**CITY OF BOULDER
CITY COUNCIL AGENDA ITEM**

AGENDA TITLE: Call-Up Item and Extension of the Call-Up Period for 745 14th St. (HIS2019-00009)

Notice of Disposition

Figure 6. Proposed east (façade) elevation. Not to scale.

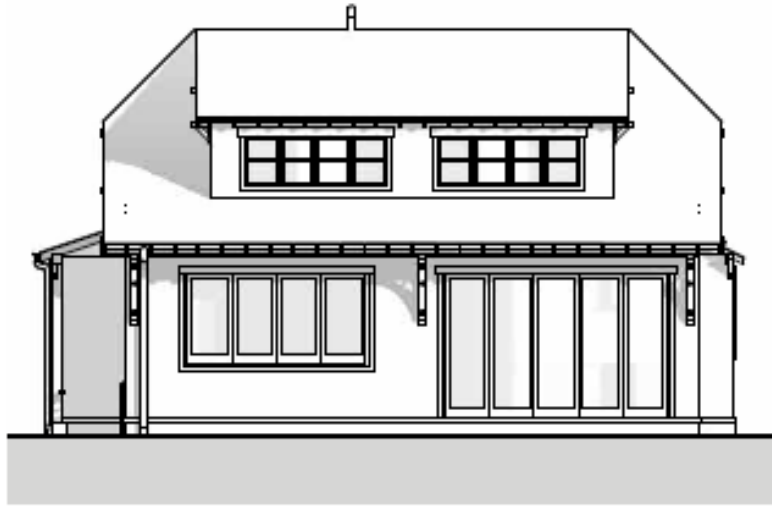
- a. Revised drawings showing:
 - Front and rear dormers lowered at least 1' below roof ridge height
 - Simplified fenestration on front and sides of house reflecting Bungalow houses in the neighborhood

- Lower height of front metal fence to no more than 3' in height
 - Reduce the amount of hardscaping along the alley
 - Design the porch depth to be consistent with the depth of contributing Bungalow porches in the historic district
